Access Compliance Report

Public Rights-of-Way

(Curb Ramps)

Intersection ID: 6474	Main Street: CENTURY_OAKS_LN	Cross Street: FALLEN_TREE_CT	Location: NE
ADA ID: 15789D472D03	Ramp Type: Perp	Initial Pass/Fail: Fail	Overall Compliance: No
Severity Score: 33.75			
Codes/Mitigation Info/Possible Solution		Field Measurements/Component Compliance

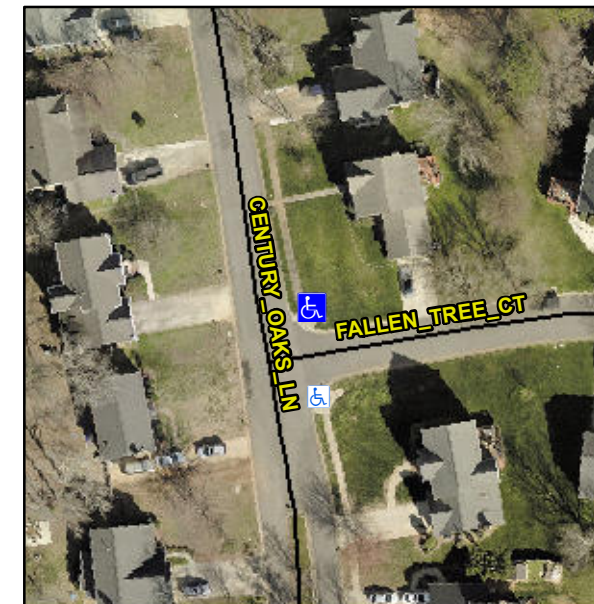
Remove & Replace Entire Ramp.

R304.5.1, R304.5.3

Compliance	Description	Data	Compliance	Description	Data
N/A	Ramp Length (in)	49.0	Yes	Ramp Slope (%)	7.7
No	Ramp Width (in)	44.0	No	Ramp XSlope (%)	7.6
N/A	Flare Type LT	N/A	N/A	Flare Type RT	N/A
N/A	Flare Slope LT (%)	N/A	N/A	Flare Slope RT (%)	N/A
N/A	Flare Traversable LT?	N/A	N/A	Flare Traversable RT?	N/A
N/A	Landing Length (in)	N/A	N/A	DWS Provided?	N/A
N/A	Landing Width (in)	N/A	N/A	DWS Contrast?	N/A
N/A	Landing Slope (%)	N/A	N/A	DWS Length (in)	N/A
N/A	Landing X Slope (%)	N/A	N/A	DWS Full Width?	N/A
N/A	Landing Curb? (Y/N)	N/A	N/A	DWS Offset (in)	N/A
N/A	Shared Landing?	N/A			
N/A	Gutter Ponding?	N/A	N/A	Gutter Slope (%)	N/A
N/A	Gutter Lip Ht (in)	N/A	N/A	Gutter X Slope (%)	N/A
N/A	Painted X Walk1?	No	N/A	Painted X Walk2?	N/A
	X Walk 1 Direction	To S		X Walk 2 Direction	N/A
N/A	X Walk 1 Width (in)	N/A	N/A	X Walk 2 Width (in)	N/A
	X Walk 1 Slope (%)	9.1		X Walk 2 Slope (%)	N/A
	X Walk 1 X Slope (%)	1.5		X Walk 2 X Slope (%)	N/A
